## Acceptance Tests and Maintenance

### 2.0.4 Principal Design Criteria for the ISFSI Pad

Figure 3.1.1: Typical Cross-Section of Anchorage Securing the Cask to the ISFSI Pad (at Location of Anchor Stud)

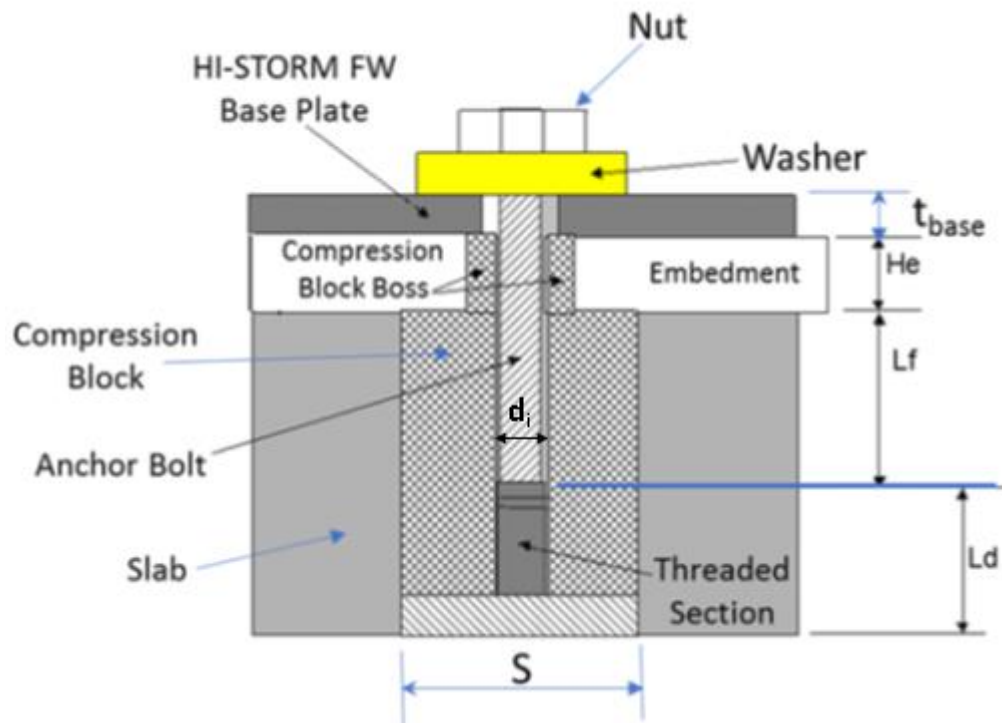
**The anchored HI-STORM overpack is positioned on a steel embedment plate engineered into the ISFSI pad such that the bolt circle diameter on the HI-STORM baseplate aligns with the anchoring locations on the ISFSI pad. The HI-STORM is anchored to the steel embedment plate**

using pre-tensioned anchor studs threaded into compression blocks to ensure a continuous compressive state of stress at the interface between the cask and the embedment plate. The design and key dimensions of the anchorage system shall comply with the requirements as shown in Figure 3.1.1. ~~typical pad~~The cask baseplate is held in contact with the embedment plate by a series of pre-tensioned anchor studs. The studs are threaded into a “compression block” that serves to induce a high compressive state of stress at the steel-steel interfaces #1 and #2 in Figure 3.1.1. Figure 3.1.1 shows the threaded compression block hole through the block thickness. The thread starting location, relative to interface #2, is set to ensure the proper free-length of the pre-tensioned anchor stud.
